El Dorado County
 Building Department
 SITE/GRADING PLAN REVIEW
 Engineer _____
 Bldg. Permit 21166
 Encroachment _____
 Grading _____

RYAN RODRIGUEZ
 4245 SCIARONI RD.
 GRIZZLY FLATS, CA 95635
 20' X 26' X 8'

COVER SHEET

20I-12-0838

PLOT PLAN
 OWNER: PETER NOBLEMAN
 NO. 806 1400 BRIZLEY PLATE CA.
 280 EITE AVENUE SCARBOROUGH, N.B. 12th FL. 10th
 PARCEL NO. 41-001-08
 SCALE 1" = 20'
 LOT AREA 5 AC.
 ZONING RESIDENTIAL
 DATE AUG 14 / 1994
 Page 5 of 5

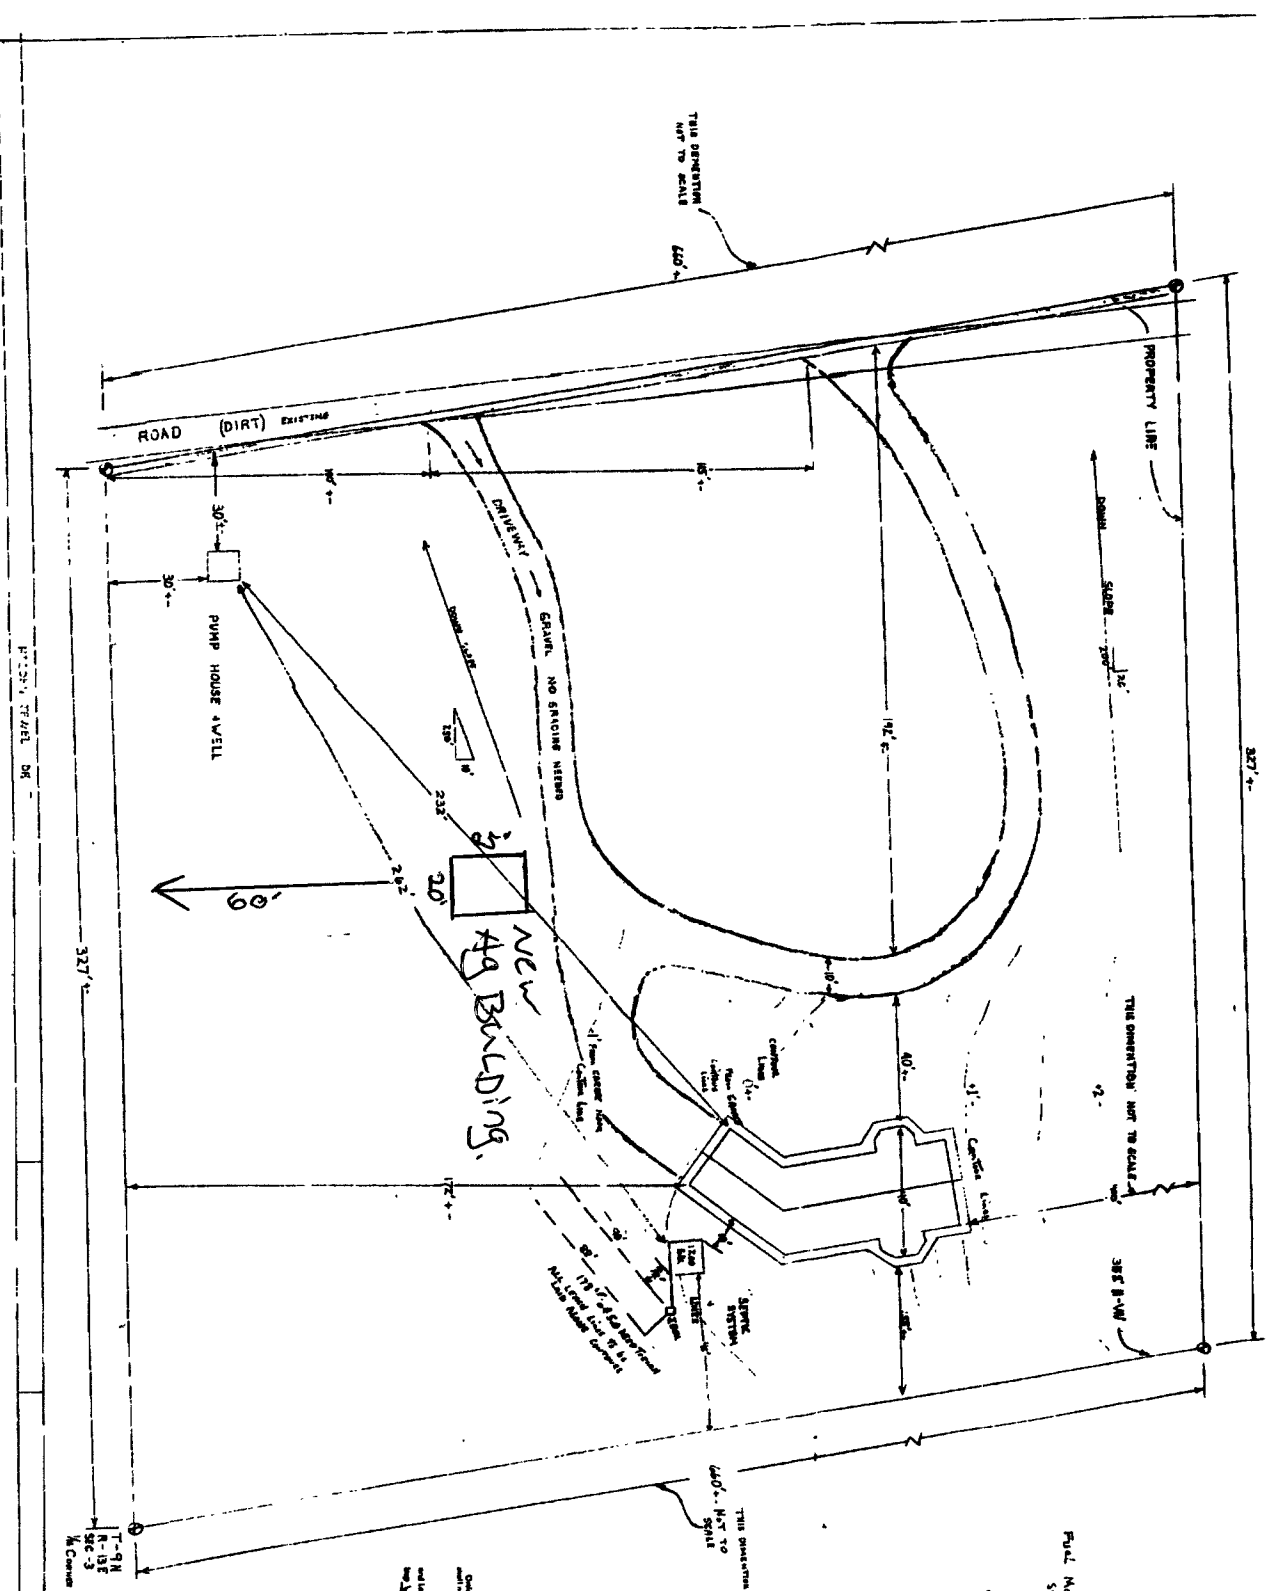
This structure is exempt from inspection, however:

The California Building Code states: "Exemption from the permit requirements of this code shall not be deemed to grant authorization for any work to be done in any manner in violation of the provisions of this code or any other laws or ordinances of this jurisdiction."

The SRA Fire Safe Regulations: "The emergency access to, and perimeter wildland fire protection of, the inspection exempt structure must adhere to the California Board of Forestry safety measures, Title 14 Natural Resources."

OWNER: RYAN RODRIGUEZ	LOCATION: 4245 SCIARONI RD. GRIZZLY FLATS, CA 95635
SHEET TITLE: ELEVATIONS	
PROJECT NO.:	20I-12-0838
DRAWN BY:	CQ
DATE:	9/18/2012
SHEET NO.:	2 OF 7

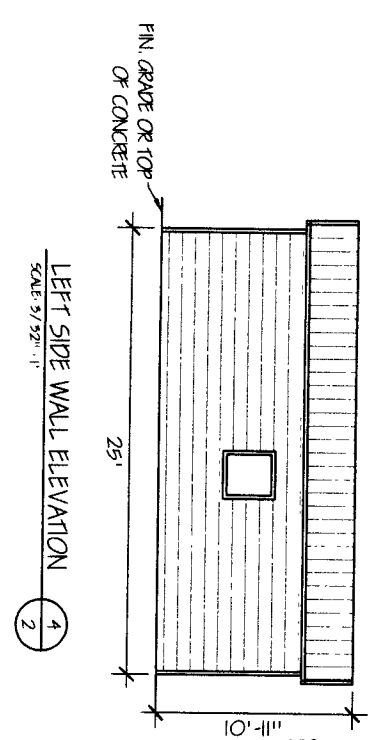
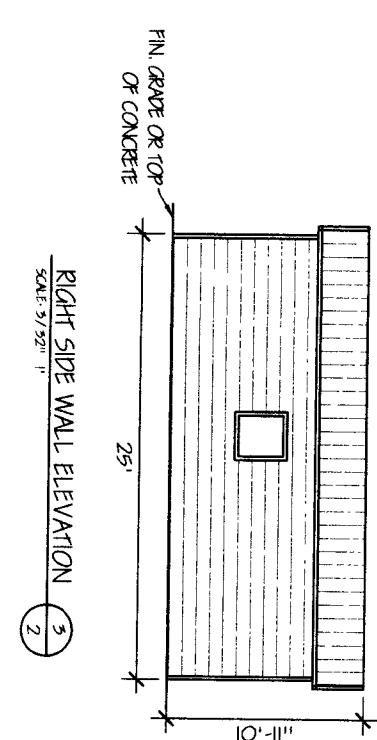
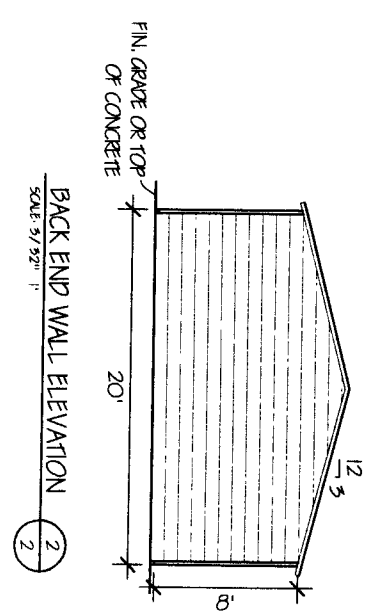
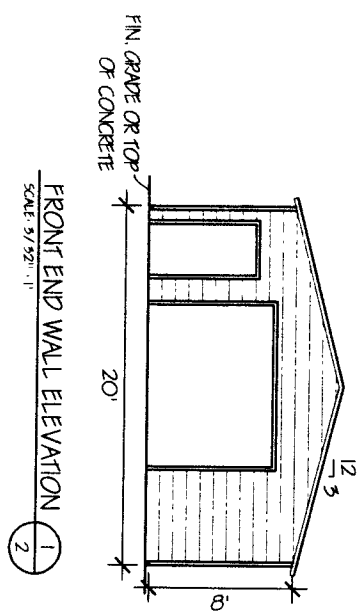
WINDOW LOCATION
AS PER CUSTOMER
